UNITED STATES PATENT AND TRADEMARK OFFICE

| APPLICATION NO. | FILING DATE | FIRST NAMED INVENTOR | ATTORNEY DOCKET NO. | CONFIRMATION NO. |
|-----------------|-------------|----------------------|---------------------|------------------|
| 09/854,919 | 05/15/2001 | Karl-Heinz Baumann | 225/49907 | 7559 |

Office Action Summary

DETAILED ACTION

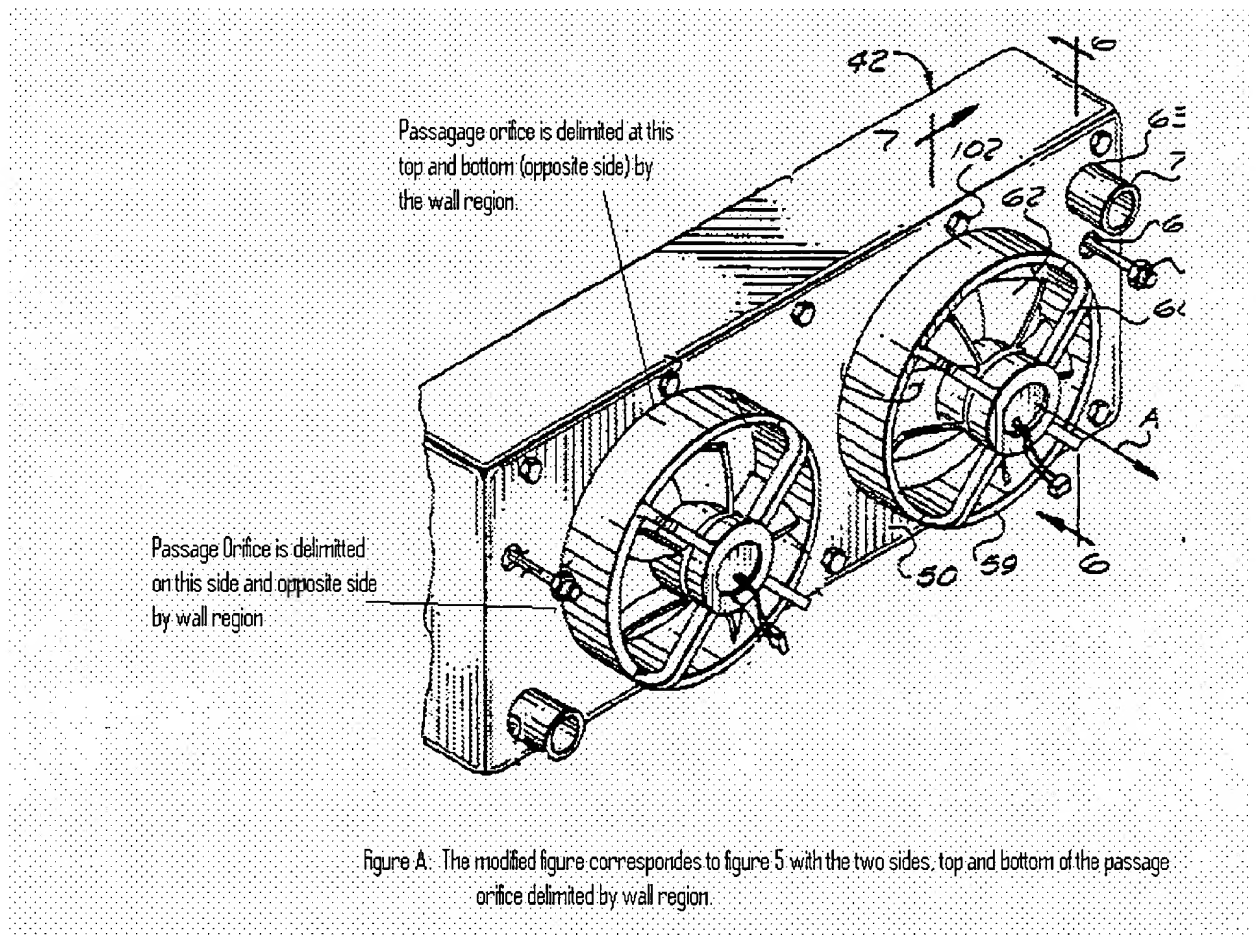
Claims 1-19 are rejected under 35 U.S.C. 102(b) as being anticipated by Iwasaki et al. (US 5,476,138). Iwasaki discloses (figures 1-7 and A as bellow) a heat exchanger arrangement on a front carrying structure of a motor vehicle, the front carrying structure having a passage

orifice (55) of a cooling air stream, which extends in a vehicle transverse plane and is delimited on two mutually opposite sides, top and bottom by wall regions (50,59) of the carrying structure, the heat exchanger arrangement comprising a radiator (43) which largely overlaps the passage orifice (50) and which is mounted on the front carrying structure in such a way that, in the event of a head on collision subjecting a region of the passage orifice to stress, the radiator while absorbing impact energy, and cooperates reinforcingly with the wall regions of the carrying structure, wherein an entire longitudinal extent of an end regions (82) of the radiator are received and fasten in sliding guides (52) define by the carrying structure and produced in one part with a front wall (50); the radiator is arranged in front of the passage orifice (55) and the upper and lower end regions (82) project beyond the passage orifice; the radiator (43) is capable to be pushed with the end regions (82) in a manner of a drawer into the guides (52) and secured in a pushed-in position via fixing elements (102). Regarding claim 4, the front carrying structure comprising a large size front wall (50,59), and the passage orifice (55) is formed in a middle of the front wall. Regarding claim 5, the method of forming the device “extruded” is not germane to the issue of patentability of the device itself. “Even though product-by-process claims are limited by and defined by the process, determination of patentability is based on the product itself. The patentability of a product does not depend on its method of production. If the product in the product-by-process claim is the same as or obvious from a product of the prior art, the claim is unpatentable even though the prior product was made by a different process.” In re Thorpe, 777 F.2d 695, 698, 227 USPQ 964, 966 (Fed. Cir. 1985). In this case, the front wall (50) has a one-piece structure, which is structurally the same with the claimed front wall because the extruded profile is a one-piece structure profile. As regarding claims 9-11, a further heat

exchanger module (44,45) is arranged in front of the heat exchanger (43) and mounted on the front wall. As regarding claim 12, the end regions (82) and the guides (52) form tongue and groove arrangement, in which the end regions (82) is received within a big groove formed by interior space of guides (52).
